Planning Commission Meeting

September 12, 2023 6:00 PM

4.I. 558 Woodrow Avenue Site Plan Review

DATE: August 24, 2023
TO: Adrienne Senter
FROM: Lynn Patterson
RE: Site Plan Review – 558 Woodrow Ave

SITE PLAN

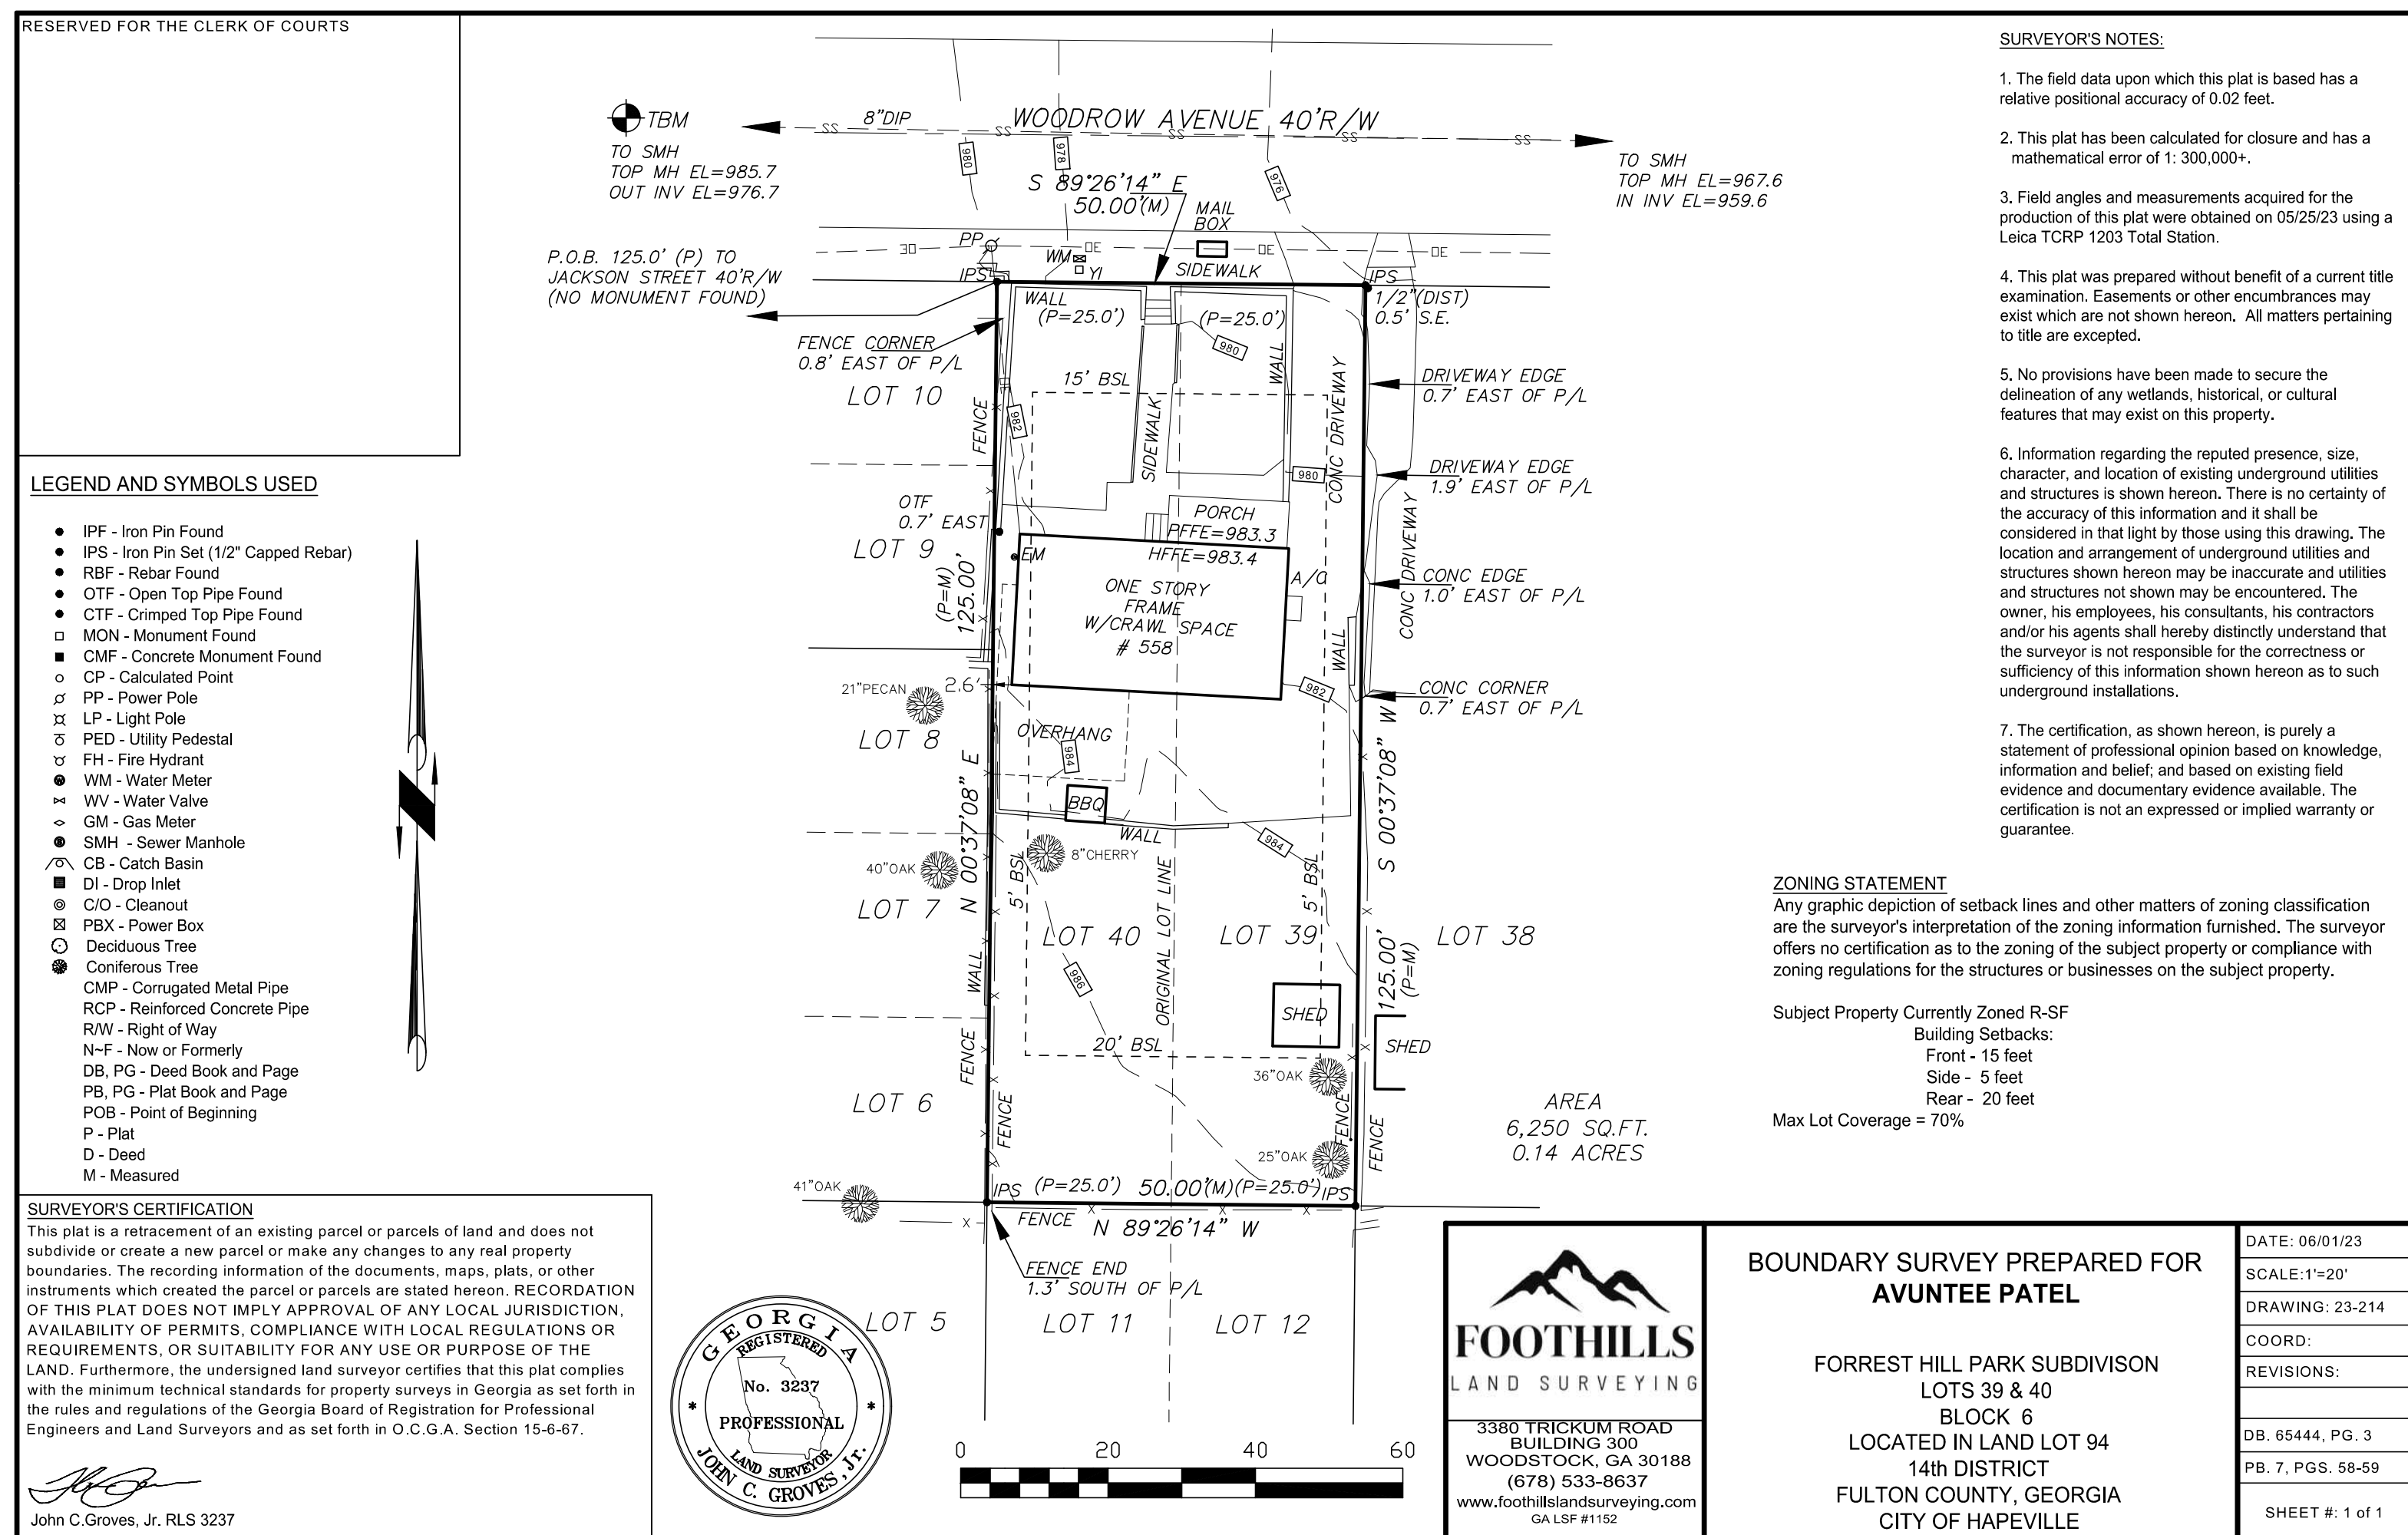
- ***Setback dimensions are not provided:***
 - ***The west side overhang on the site plan appears to encroach in the 5' setback. The elevation shows it does not, please confirm.***

- ***Front, rear and east side setback are within buildable area. Please provide dimensions to confirm. Include front stoop/concrete steps as closest point for the front and eaves to the side and rear.***

- ***The plans include a concrete driveway for which no dimensions are provided. Please provide.***
 - ***The plans do not, but should, show the existing sidewalk. Please provide.***

- ***The plans do include a walkway from the entrance to the street.***
 - c. The locations, area and number of proposed parking spaces.
 - ***The plans show parking along the side of the house. The length of the driveway past the front façade of the house must accommodate two cars. Designated parking is not permitted in the supplemental area.***

- d. Existing and proposed grades at an interval of five feet or less.
 - ***Grades are shown at 2' intervals on the original survey but not on the site plan. Will any grading be done? Please confirm.***

- e. The location and general type of all existing trees over six-inch caliper and, in addition, an identification of those to be retained.
 - ***There are 3 trees on the lot, a 25" Oak, 36" Oak, and an 8" Cherry. The neighboring 40" Oak will be impacted by the construction/addition. The applicant must follow all regulations in the Tree Conservation Ordinance for notification. Please provide tree conservation plan.***

- *Provide dimensions for concrete driveway including width, length, and length beyond front façade of house.*
- *Show the existing sidewalk on the site plan.*
- *Provide actual height from grade*
- *Provide front, side, and rear setback dimensions of house. Include front stoop/concrete steps as closest point for the front and eaves to the side and rear.*
- *Provide confirm eaves are not in the setback.*
- *Confirm if any on site grading will be done.*
- *Show rear setback dimensions.*
- *Provide a tree conservation plan.*
- *Provide a development schedule.*

Upon remedy of the aforementioned deficiencies (with particular attention paid to setback encroachment of the dwelling), the site plan is compliant. A variance for encroachment in the side setback would require a conditional approval from the Planning Commission.
